# Uncompany Valley Reclamation Project

## **AB** Lateral Hydropower Facility

## Final Environmental Impact Statement Volume II, Comments and Responses

**Bureau of Reclamation**

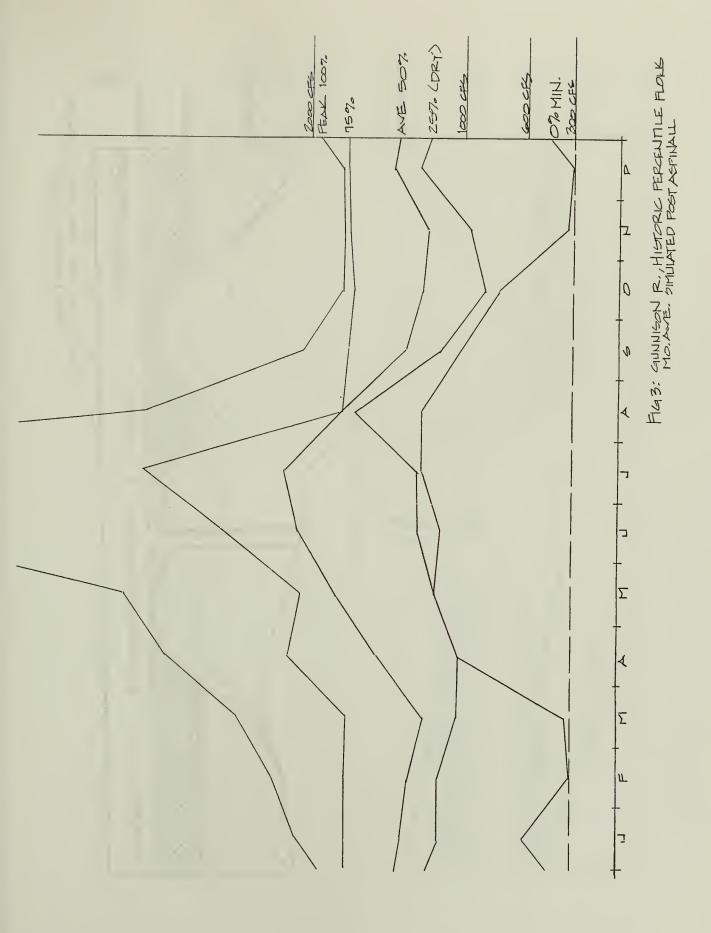
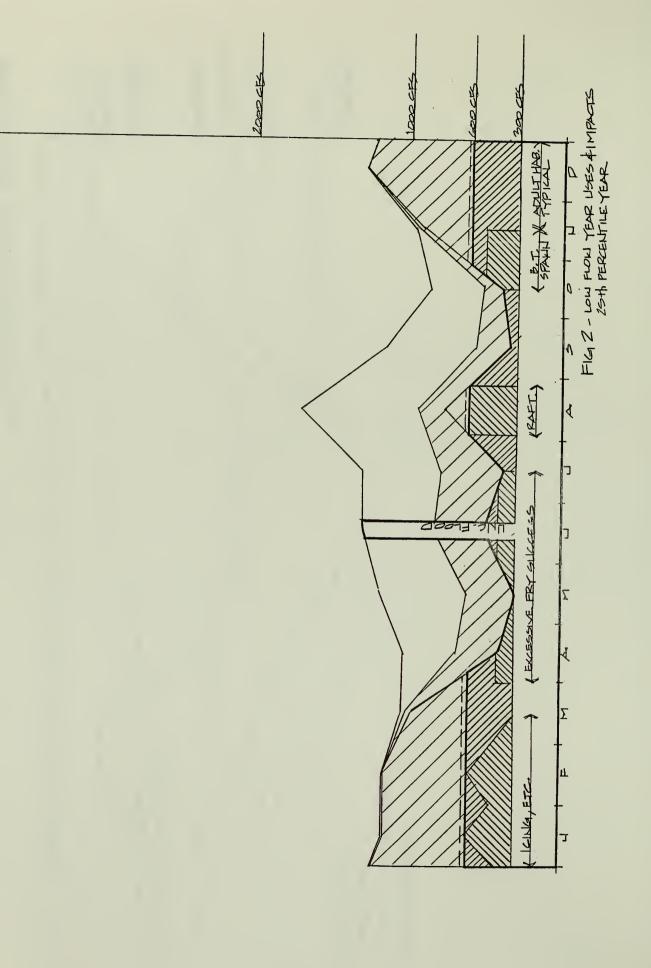
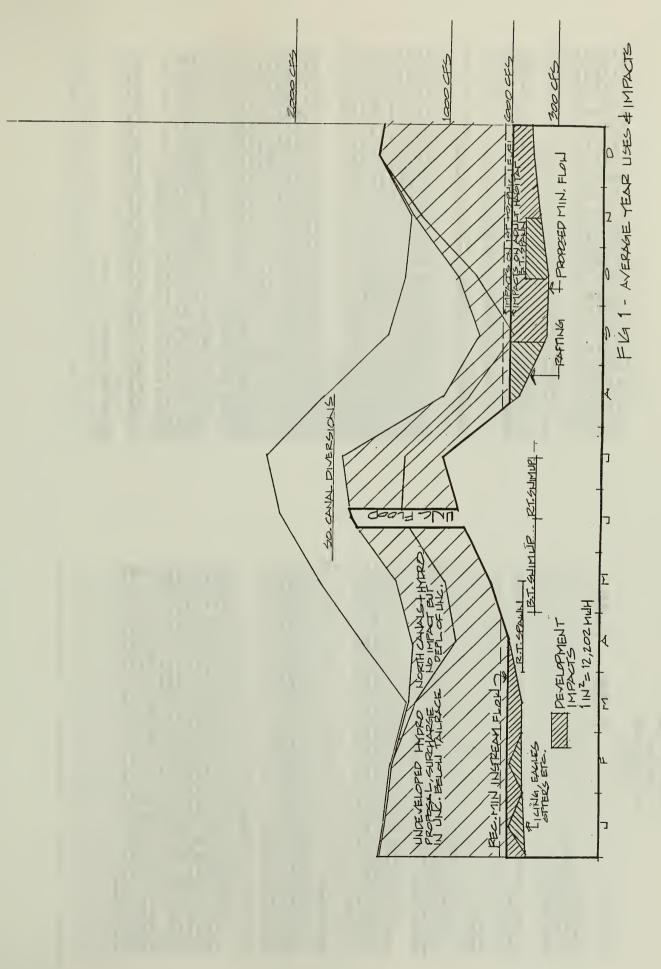
Figure 1 charts average monthly Gunnison flows, diversions and proposed The heavy line shows what The hatched area below this show what I consider to be the volume of unreasonable demands on the be seen here that in average or better years a reasonable flow requirement would only withhold a small percentage of proposed diversions from be a reasonable minimum instream flow. impacts for the average year between 1965 and 1983. power production, perhaps 15%. to I would consider river. It can

Figure 2 charts average monthly Gunnison flows, diversions and proposed impacts for the dry years between 1965 and 1983. This was taken from the 5th driest month during the 19 year period, or roughly a 25th percentile year. these low flows, however, were reached 6 and 7 times during this Again the heavy line shows what I consider to be a reasonable minimum flow while the hatched area below it says "too much". To achieve reasonable minimums in this one year in four, proposed power production would need to be curtailed by about 35%, of instream period. Some (

Figure 3 charts historic percentile monthly average flows from the DEIS simulated post Aspinall flow data.
